Product Change Notice

PCN#: EE-PCN25009

PN change to create standard and alternate PN classification for TVS diode products.

Example of Standard and Alternate TVS Diode Catalog PNs found on datasheet.

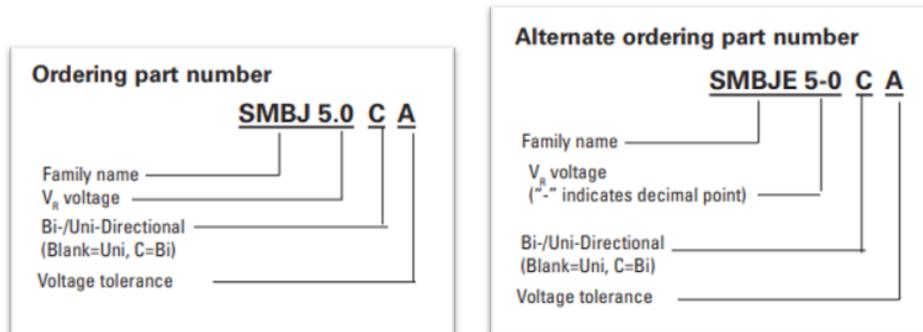
A subset of the Eaton TVS diode product family is now available with standard and alternate catalogue PN's. The standard PN's match the industry standard TVS diode naming convention, while the alternate catalogue PN's match the preexisting Eaton naming convention. The standard and alternate PN's are identical and interchangeable, and one may be shipped as replacement for the other if stock is available. This will be evident by the PN on the packaging label, whereas the physical products, part marking, etc. are identical.
